**AMENDMENTS TO THE DRAWINGS**

Application No. 10/735,488

**ANNOTATED SHEET SHOWING CHANGES TO FIGURE 7**

FIG. 7  
(PRIOR ART)

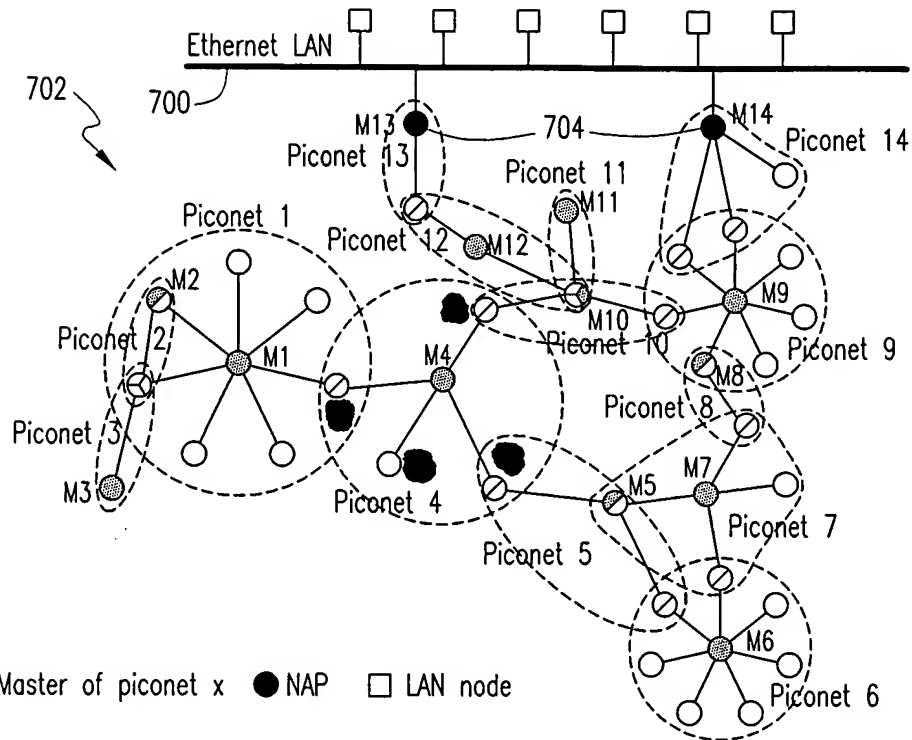
Figure 7 of the drawings is hereby amended to add the reference labels "S1," "S2," "S3," and "S4" to the four nodes directly connected to node "M4." Support for the amendment may be found in the specification in the paragraph bridging pages 31 and 32.
